# PREVOST

### WB24-27

DATE :	August 2024	SECTION:	06 ELECTRICAL
EXPIRATION:	August 2026		
SUBJECT:	<b>HARNES CONNECTORS MODIFICATION</b>

On the vehicles affected by this bulletin, modify the connectors harness pin out and fuse.

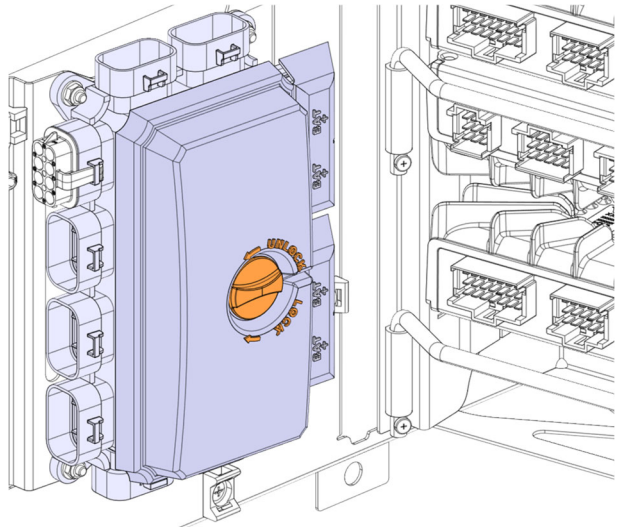
8. Replace the fuse **F130** with the new 563153.

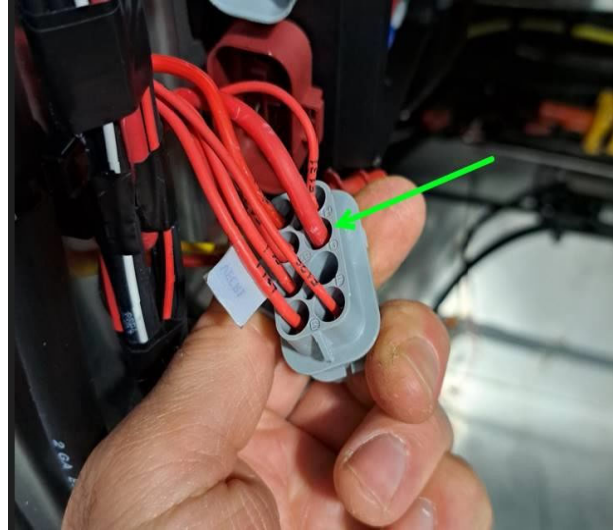
12. Extract the terminal from the position **C** of the connector **VECR2** (red).

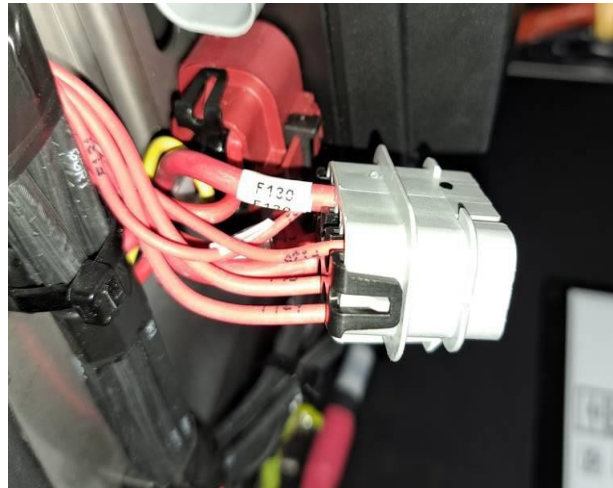
13. Insert the terminal at position **G** of the connector **VECR1** (gray)

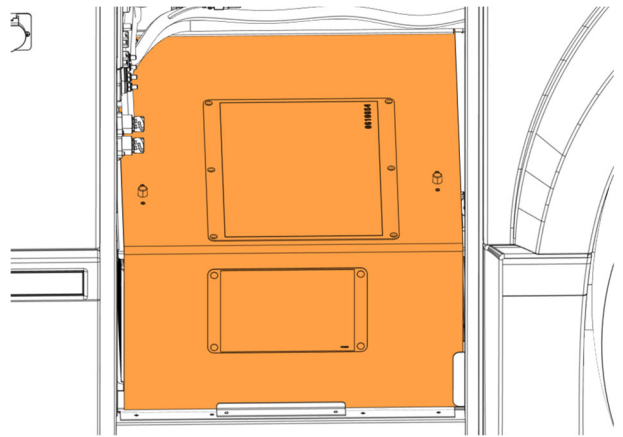
19. Modify the decal of the rear junction box components label printer "P-TOUCH":  
 Change F130: 25AMP P.RACK FAN  
 Change F145: SPARE
